Accessibility Evaluation

Monroe County Polling Location

Harrodsburg Community Center
1002 W Popcorn Rd
Bloomington, IN 47403

Report Date: 04/07/2026

Finding: 3

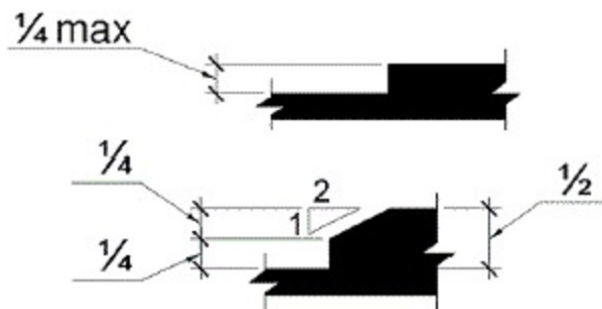
The threshold is greater than 1/2 inch high on the exterior side of the door.

The threshold at a doorway shall be no higher than 1/2 inch. Changes in level between 1/4 inch and 1/2 inch must be beveled at 1:2 or less. 1/4 inch is the maximum vertical rise.

2010 ADAS Section 404.2.5

Add a temporary or permanent threshold reducer.

Finding: 4

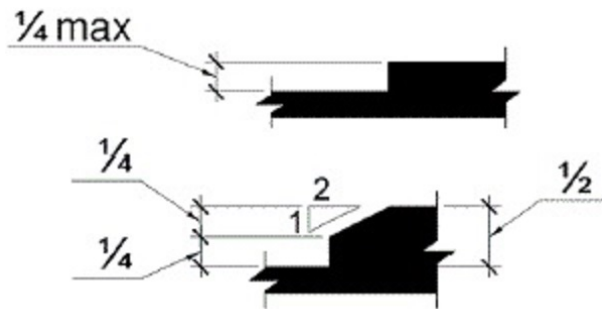
The threshold is greater than 1/2 inch high on the interior side of the door.

The threshold at a doorway shall be no higher than 1/2 inch. Changes in level between 1/4 inch and 1/2 inch must be beveled at 1:2 or less. 1/4 inch is the maximum vertical rise.

2010 ADAS Section 404.2.5

Add a temporary or permanent threshold reducer.
